**THE REGIONAL MUNICIPALITY OF YORK
ADDENDUM # 4
T-16-11**

FOR: Construction of the New Paramedic Response Station# 19
LOCATION: 415 Harry Walker Parkway South, in the Town of Newmarket, Ontario
CLOSING: November 15, 2016 at 1:00 P.M. (Local time)

STRUCTURAL ADDENDUM #1

Project Name: Paramedic Response Station #19 - York Region

2.1 REFERENCE STRUCTURAL DRAWING S2-01

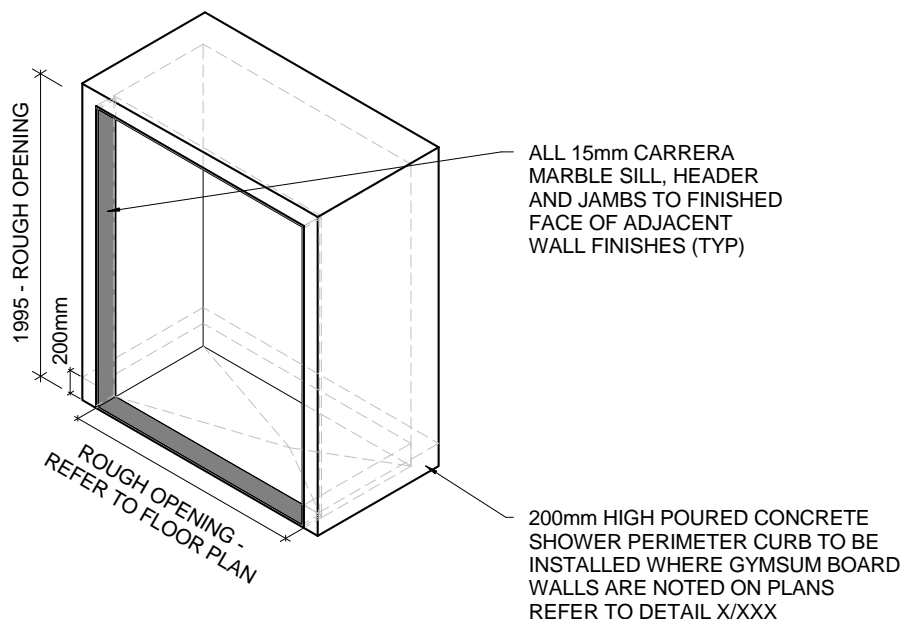
Q10 Please provide distance between underside of baseplate to ground floor SOG. This information is missing from the column schedule.

- .1 Underside of baseplate elevation added to column schedule which indicated the underside of baseplate to be at -350mm from FFE
- .2 Details T-S01 and T-S11 updated to include a dimension showing 50 mm of grout below the base plate. 100 mm minimum project of the anchor rods above the grout bed.
- .3 Anchor rod note in detail T-S11 updated to read 'REFER TO THE COLUMN SCHEDULE AND PLAN DETAILS. ANCHOR PLATE TO BE 100X13X100'
